**GLADSTONE**  
REGIONAL COUNCIL

**GENERAL MEETING NOTICE  
AND AGENDA**

### G/4.1. DEVELOPMENT APPLICATION DA/12/2023 FOR RECONFIGURATION OF A LOT - 1 LOT INTO 2 LOTS LOCATED AT 3 SEASPRAY DRIVE, AGNES WATER QLD 4677

The purpose of this report is to decide Development Application 12/2023 for Reconfiguring a Lot (1 lot into 2 lots) on land at 3 Seaspray Drive, Agnes Water against the *State Planning Policy July 2017*, and the *Our Place Our Plan Gladstone Regional Council Planning Scheme Version 2* under the *Planning Act 2016*.

Figure Four: Proposed Subdivision Plan

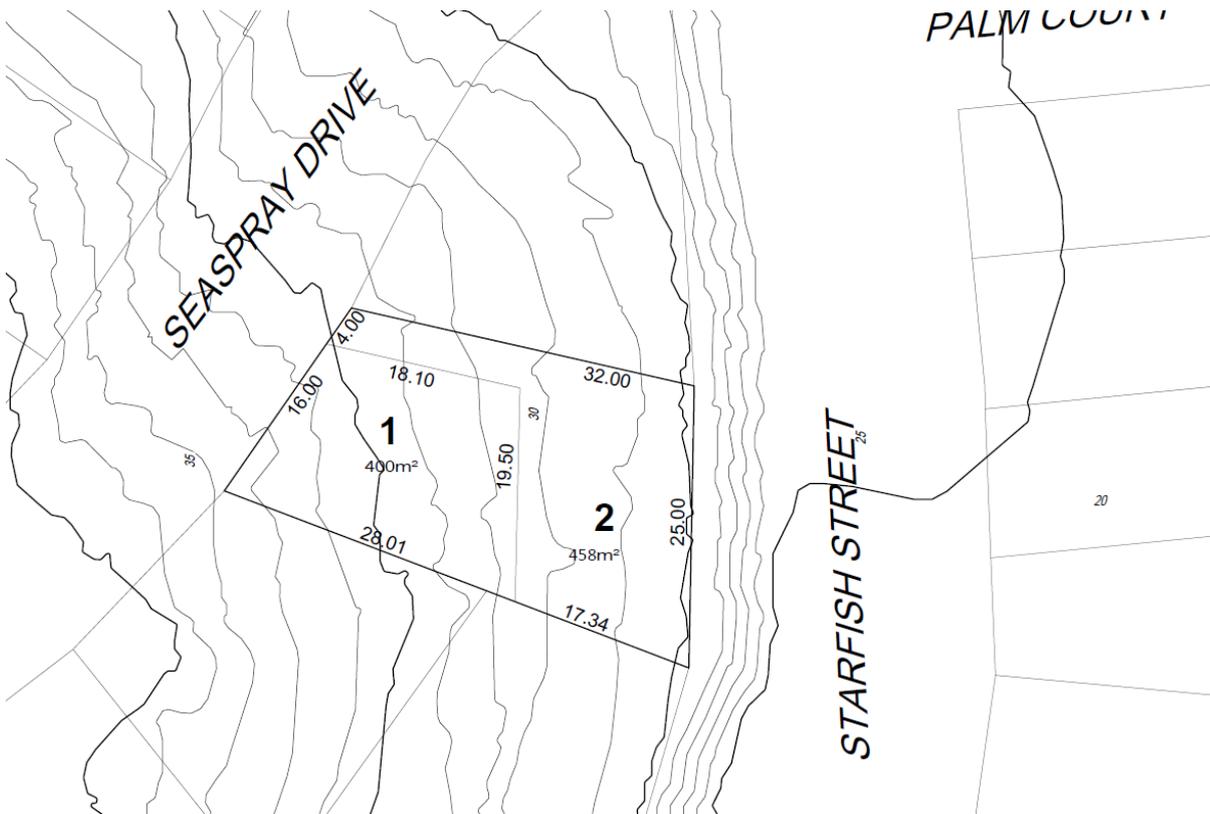
The Code prescribes minimum lot size and frontage for lots within the Low density Residential Zone as 600m<sup>2</sup> and 17m respectively. The proposed development leads to lot sizes of 400m<sup>2</sup> and frontage of 16m for proposed Lot 1 and approximately 390m<sup>2</sup> (excluding access handle) and 4m frontage to Seaspray Drive for proposed Lot 2. Assessment against Performance Outcome 1 is required given non-compliant lot sizes and frontage widths.

The proposed building envelope of 180m<sup>2</sup> is considered as insufficient in size to accommodate a typical dwelling in character with this neighbourhood. It is evident that the opportunity cost for providing compliant setbacks as well as required easements over Council's sewer and stormwater infrastructure, is the provision of a reduced size, non-complaint building envelope. Additionally, the topography of the site and the absence of a geo-technical report leads to additional uncertainty of the functionality and useability of the proposed 180m<sup>2</sup> building envelope. This poses the question of whether the proposed subdivision is truly feasible in this location as well as facilitating the achievement of the sustainable urban outcomes expressed in the Low Density Residential Zone. A building envelope with minimum dimension of 300m<sup>2</sup> is identified by the Planning Scheme as adequate in promoting the purpose of a single dwelling house and ensuring that the amenity of adjoining lots would not be detrimentally affected as outlined in Performance Outcome 2 of the Reconfiguring a lot Code.

Figure Five: Steep Land Overlay

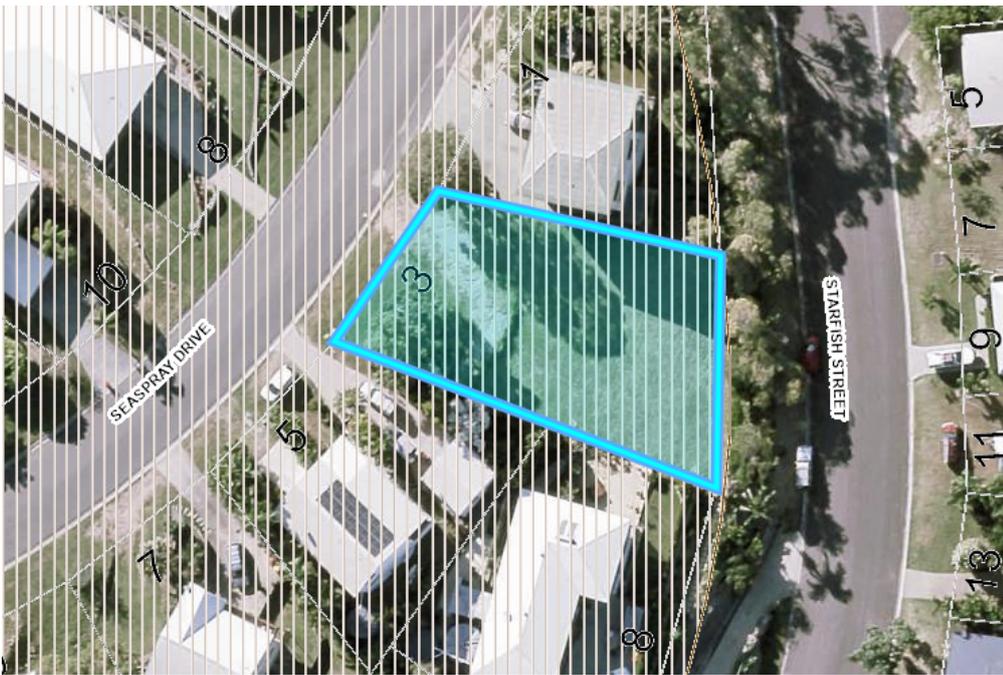
The entire subject site is encumbered by the steep land overlay which is illustrated in Figure Five below. The proposed development is for a subdivision and does not include any further development proposals. Although, the Applicant has identified the future intent for each proposed lot as a single dwelling house.

The Applicant did not provide a site-specific geotechnical report to demonstrate that the site's stability would be maintained and that the risk of landslide would not be increased. The justification of this was based on the fact that risk associated with landslides would be assessed as part of any future developments.

Given the absence of a site-specific geotechnical report, it is difficult to assess the stability of the sites including the construction and operational life of the new allotments (including associated buildings). The proposal is therefore not compliant with AO1.2 and PO1.

Figure Seven: Revised Site Plan

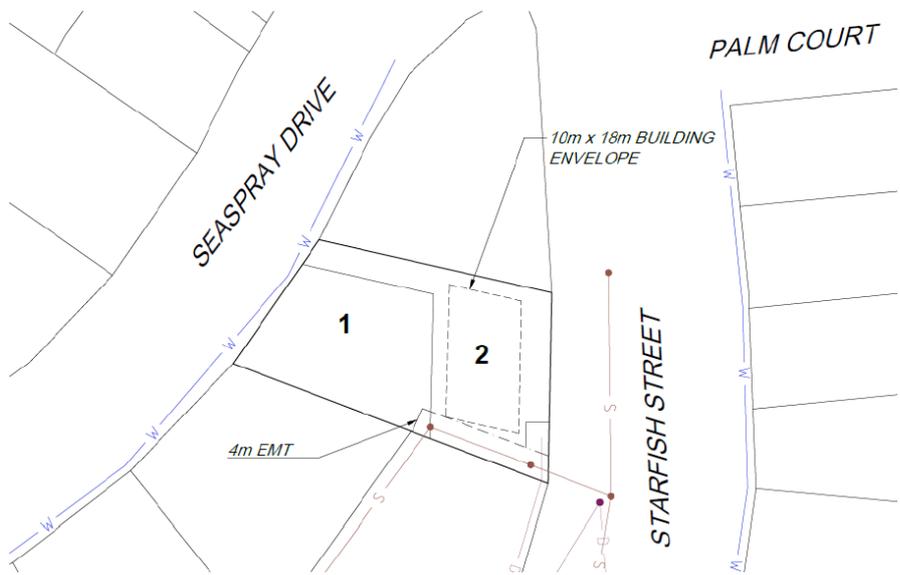
Further clarification was sought in the Information Request dated 11 April 2023 regarding building envelope requirements and information on proposed retaining walls (if required). Council requested amended plans demonstrating a building envelope with minimum dimension of 300m<sup>2</sup> exclusive of any required easements and compliant with QDC MP1.2 setback requirements. The Applicant submitted revised plans, illustrated in Figure Seven below, demonstrating a building envelope of size 180m<sup>2</sup> deemed by the Applicant as adequate in facilitating a single storey or larger 2-storey Dwelling House with ancillary structures and outdoor space. The revised plan also demonstrated the provision of a 4m wide easement along the southern boundary. The Applicant also advised of 2m side boundary setbacks and 4m reduced front boundary setback. As a site-specific geotechnical report was not provided by the Applicant, it is difficult to ascertain the suitability of the proposed building envelope on Proposed Lot 2.

Regarding clarification on retaining walls, Council has requested revised plans illustrating the proposed cut and fill heights, location, and size of retaining walls. The Applicant responded by stating that *the proposed subdivision does not intend to conduct any major earthworks that would result in the need for retaining walls throughout each proposed allotment. Additionally, any future Dwelling House/s will be required to address the sloping allotment and potential earthworks in accordance with the Planning Scheme prior to Building Works. This approach will assist in reducing significant building pads with substantial retained areas to accommodate a slab on ground built form outcome; which is generally avoided in the Agnes Water region.*

The Applicant's response is considered unsatisfactory and does not address the requirements of Acceptable Outcome 3.1 given amended plans detailing proposed cut and fill heights, location, and size of retaining walls were not provided. Therefore, Council is unable to determine compliance with AO3 or PO3 (provided as follows).
